Access Compliance Report

Public Rights-of-Way

(Curb Ramps)

Intersection ID: 49926	Main Street: CAMPBELL_HALL_CT	Cross Street: WOBURN_RD	Location: SW
ADA ID: 0ECF6B653A7A	Ramp Type: Perp	Initial Pass/Fail: Fail	Overall Compliance: No
Severity Score: 21.25			
Codes/Mitigation Info/Possible Solution		Field Measurements/Component Compliance

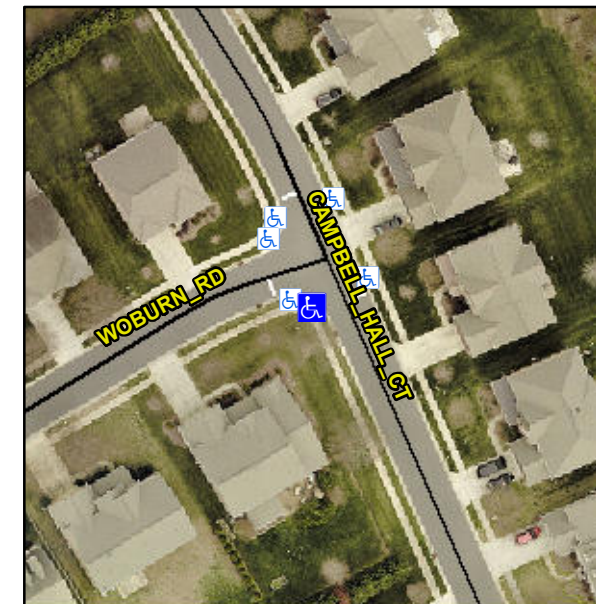
Not Found, R304.5.1, R304.2.2

Compliance	Description	Data	Compliance	Description	Data
N/A	Ramp Length (in)	46.0	No	Ramp Slope (%)	10.4
No	Ramp Width (in)	47.0	Yes	Ramp XSlope (%)	1.9
N/A	Flare Type LT	N/A	N/A	Flare Type RT	N/A
N/A	Flare Slope LT (%)	N/A	N/A	Flare Slope RT (%)	N/A
N/A	Flare Traversable LT?	N/A	N/A	Flare Traversable RT?	N/A
N/A	Landing Length (in)	N/A	N/A	DWS Provided?	N/A
N/A	Landing Width (in)	N/A	N/A	DWS Contrast?	N/A
N/A	Landing Slope (%)	N/A	N/A	DWS Length (in)	N/A
N/A	Landing X Slope (%)	N/A	N/A	DWS Full Width?	N/A
N/A	Landing Curb? (Y/N)	N/A	N/A	DWS Offset (in)	N/A
N/A	Shared Landing?	N/A			
N/A	Gutter Ponding?	N/A	N/A	Gutter Slope (%)	N/A
N/A	Gutter Lip Ht (in)	N/A	N/A	Gutter X Slope (%)	N/A
N/A	Painted X Walk1?	No	N/A	Painted X Walk2?	N/A
	X Walk 1 Direction	To NE		X Walk 2 Direction	N/A
N/A	X Walk 1 Width (in)	N/A	N/A	X Walk 2 Width (in)	N/A
	X Walk 1 Slope (%)	2.0		X Walk 2 Slope (%)	N/A
	X Walk 1 X Slope (%)	2.3		X Walk 2 X Slope (%)	N/A

Remove & Replace Entire Ramp.
